SUMMARY OF CONCERNS IN RELATION TO THE PROPOSED NORTHCONNEX TUNNEL

This is an objection to many aspects of the proposed NorthConnex tunnel.

However, on careful reading of the NorthConnex Environmental Impact Statement (EIS), we have serious concerns with regard to the tunnel project as it is currently proposed in the EIS. Our concerns are detailed in six sections which show the changes we consider necessary to make the project acceptable.

MOTORWAY OPERATIONS COMPLEX - SOUTHERN VENTILATION FACILITY - SECTIONS
M1-M2-5000-DR-JD-0525

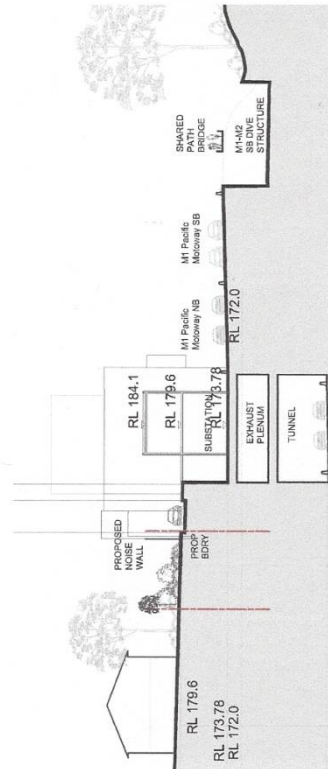
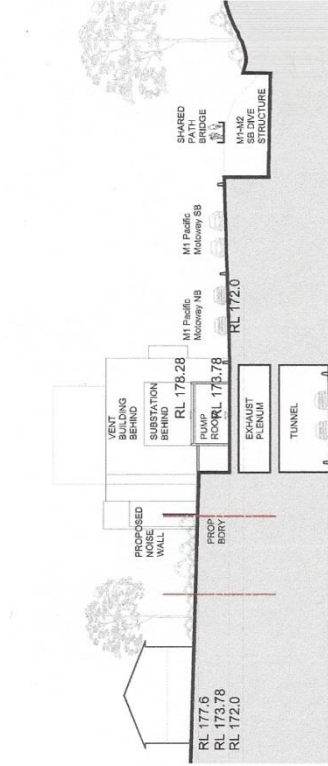
5. *EIS Volume 4, Technical working papers - Urban Design, 6.0 Operational Ancillary Facilities*
EIS Page 99 there is the diagram "Motorway Operations Complex – Southern Ventilation Facility – sections. *Page 10 below* The diagram has the cryptic label "Connection to tunnel TBC". What does TBC stand for? To be considered? Why is tunnel singular? Which tunnel is the diagram referring to northbound or southbound? There is no diagram showing any connection from the Southern Interchange ventilation facility to either the northbound or the southbound tunnel in any way
AND YET

- Diagrams need to be provided showing the inter-relation between the shaft, the ventilation outlet and the motorway operations centre with a clear description of what is to be constructed and how it will operate.
- The community needs irrefutable evidence that the polluted air from the southbound tunnel exit portals will not be allowed to flow like an invisible sewer through West Pennant Hills, North Rocks, Carlingford and Beecroft.

M1-M2-5000-DR-UD-0550
NORTHERN VENTILATION FACILITY - CROSS SECTIONS

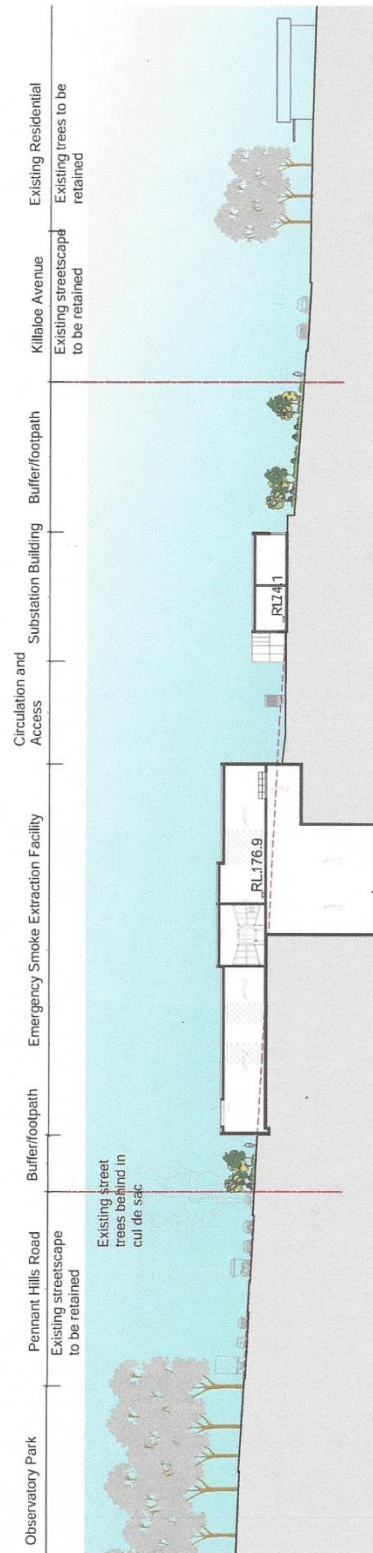
EIS page 135 *Page 11 below* there is a very explicit diagram showing the *Northern Ventilation Facility – cross section*.

EIS page 134 *Page 12 below* there is a very explicit diagram showing the *Northern Ventilation Facility – long section*.
